ARCHITECT'S SUPPLEMENTAL INSTRUCTIONS

Project:	Lumberyard District – Buildings 2, 6, 8 & 9 Omaha, NE	Initiated By		Distributed To	
Project Number:	15927	<input type="checkbox"/>	Owner	<input checked="" type="checkbox"/>	
Owner:	Lanoha Development	<input type="checkbox"/>	Architect	<input checked="" type="checkbox"/>	
To Contractor:	Overland Constructors 5036 South 135 th Street Omaha, NE 68145	<input type="checkbox"/>	Contractor	<input checked="" type="checkbox"/>	
		<input checked="" type="checkbox"/>	Consultant	<input checked="" type="checkbox"/>	
		<input type="checkbox"/>	Field	<input type="checkbox"/>	
		<input type="checkbox"/>	Other	<input type="checkbox"/>	
Supplemental Instruction No.:	004				
Date:	July 8, 2016				
Contract Date:	February 15, 2016				
Contract For:	New Construction				
By:	Holland Basham Architects

Description: Revise data locations and deck light fixtures in the units.

PROJECT: 15927
 DATE: 2/15/2016
 SHEET: E6.01

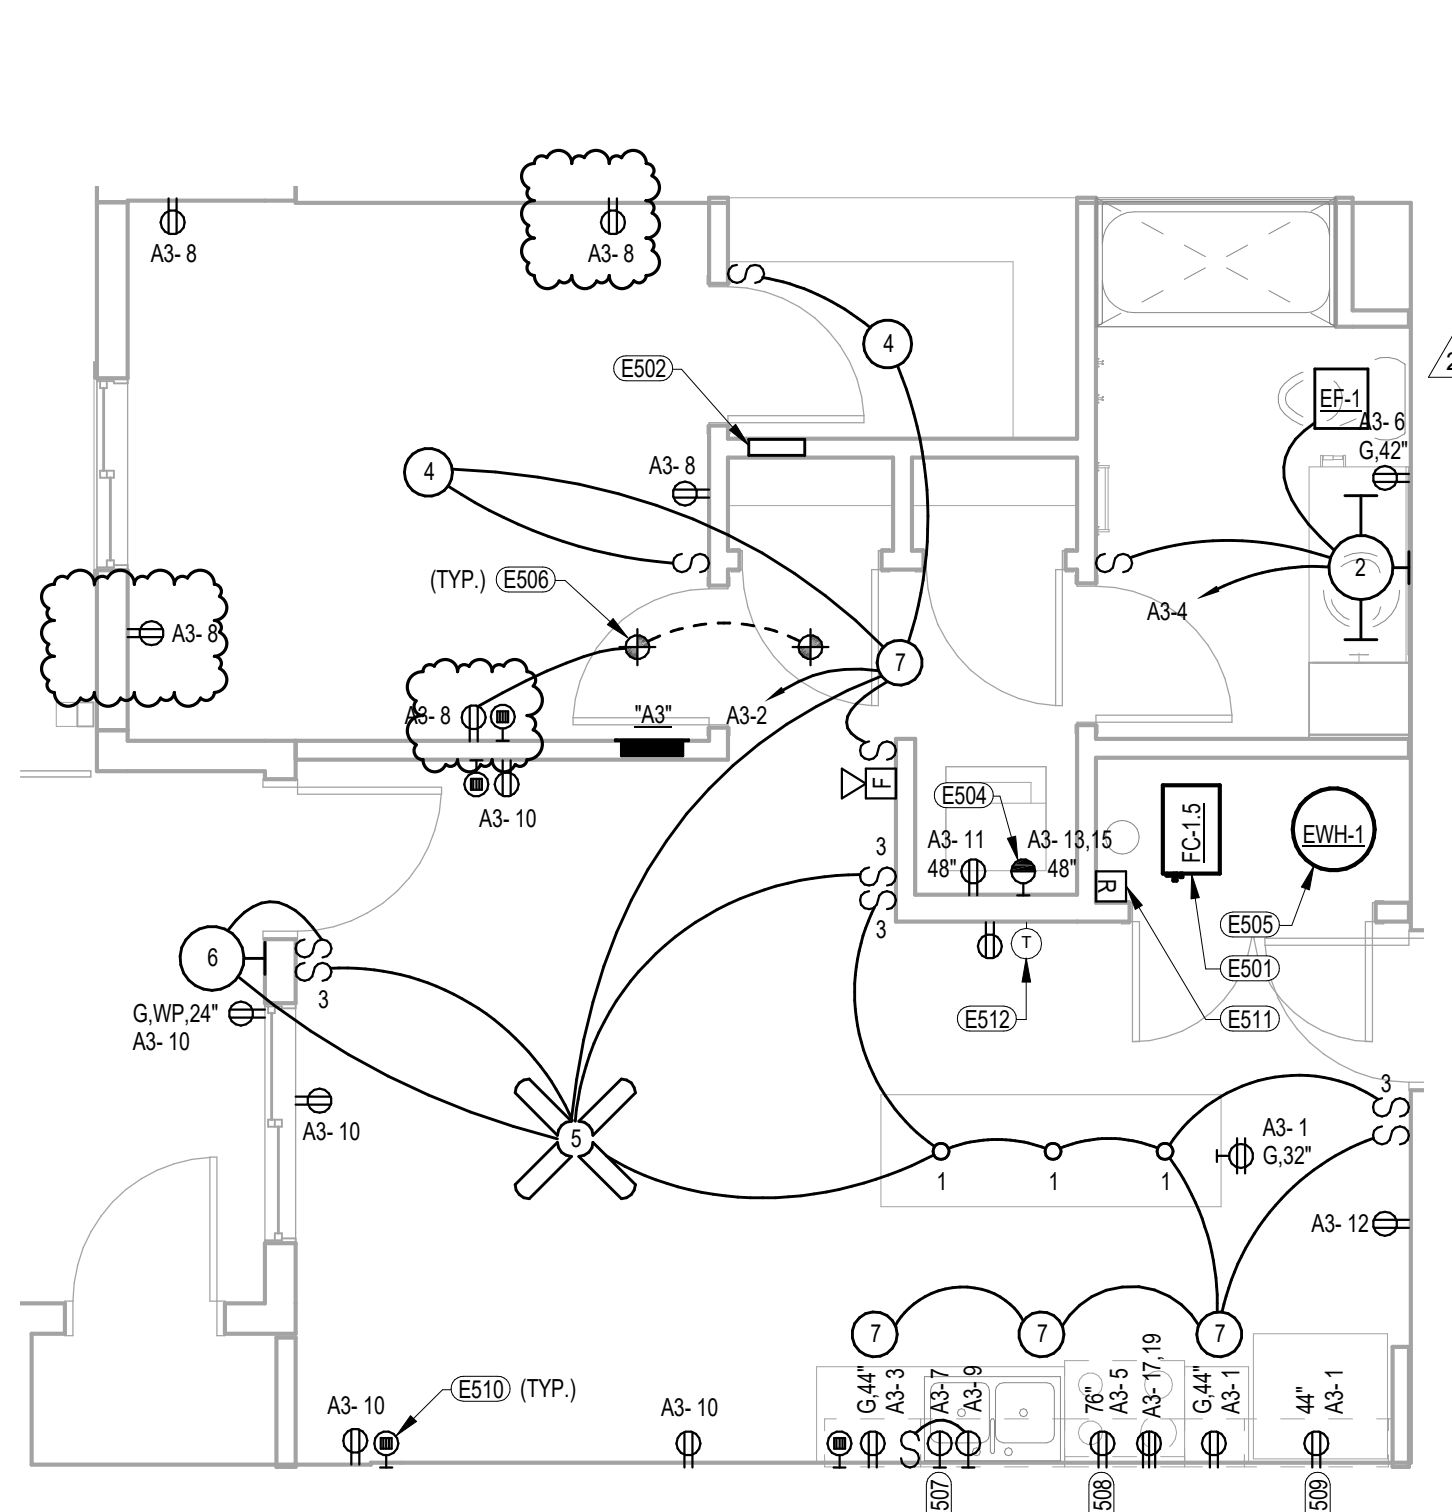
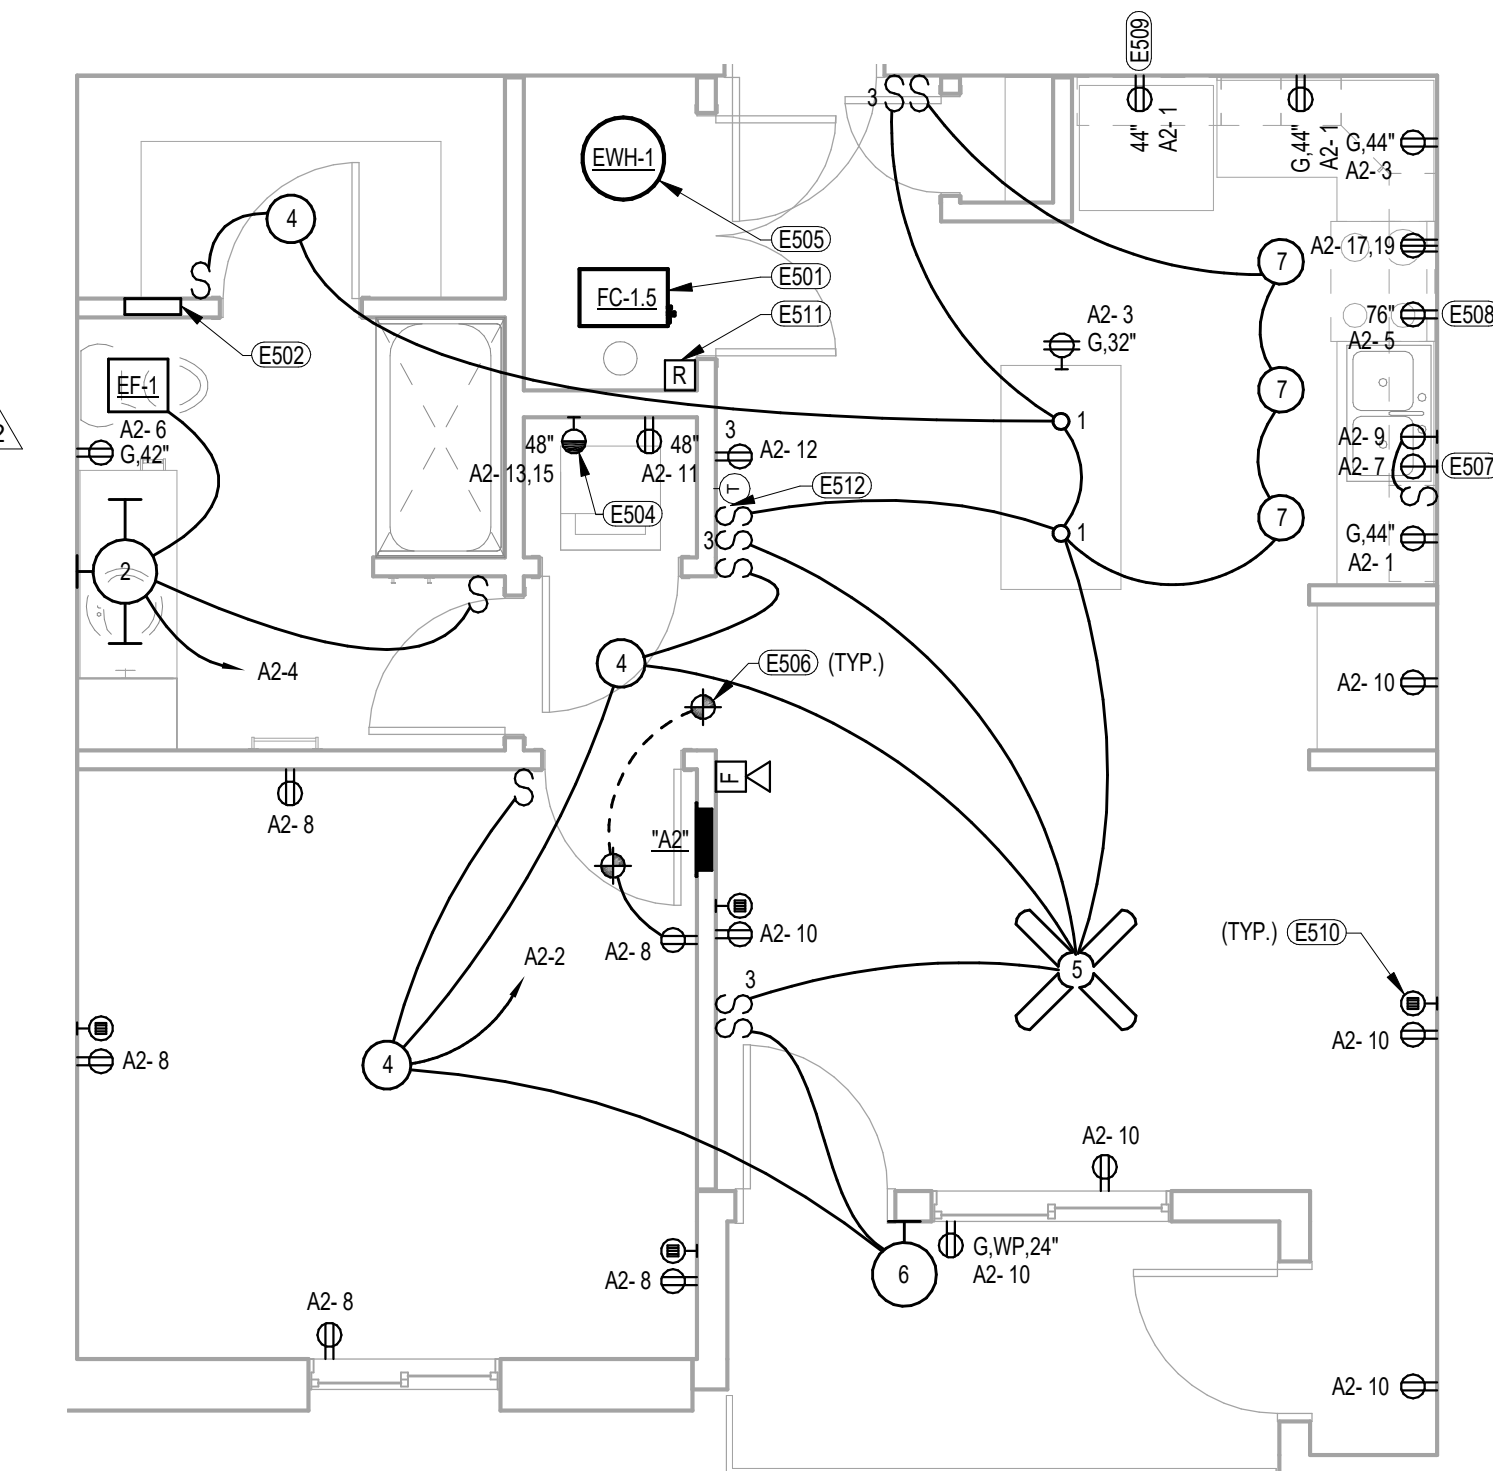
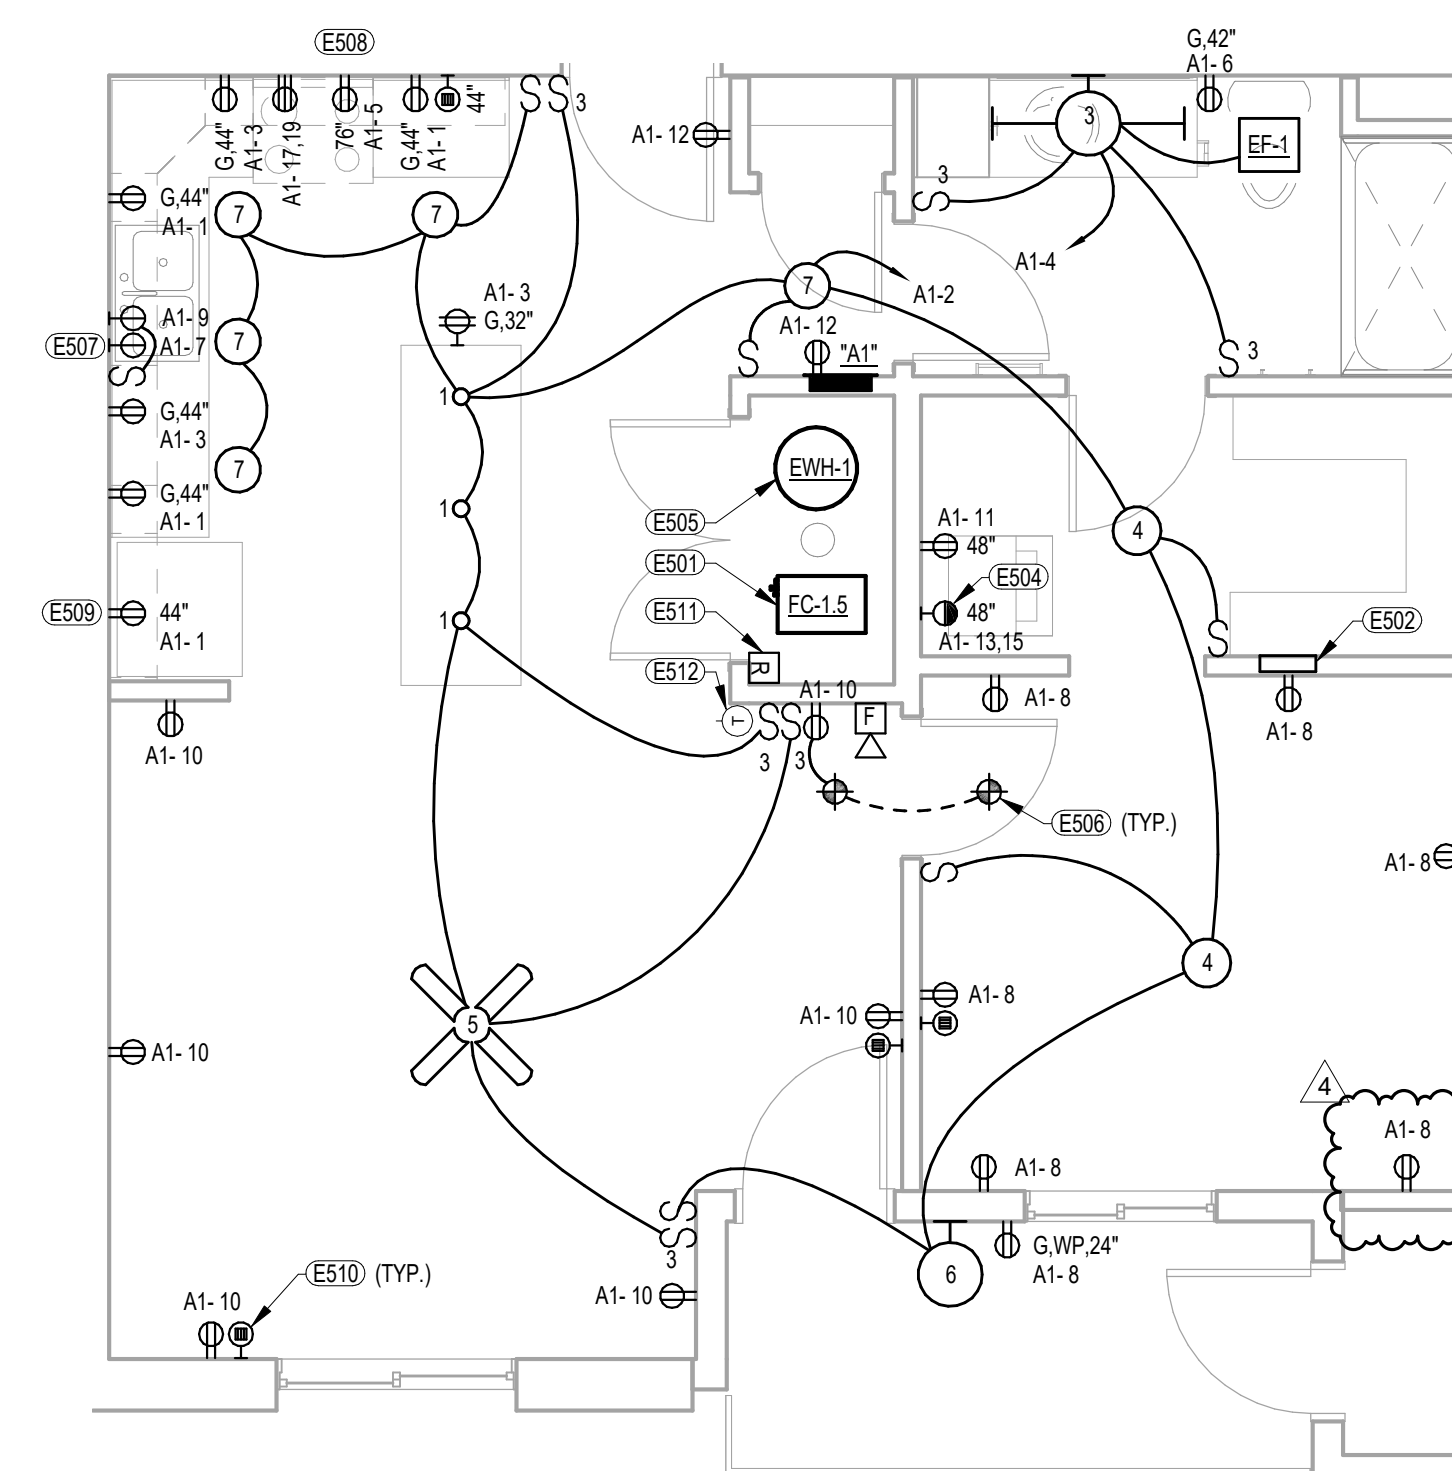
1. Sheet E6.01 – Enlarged Unit Plans - Electrical
 - a. Revise unit plans as shown in the attached Sheet E6.01.
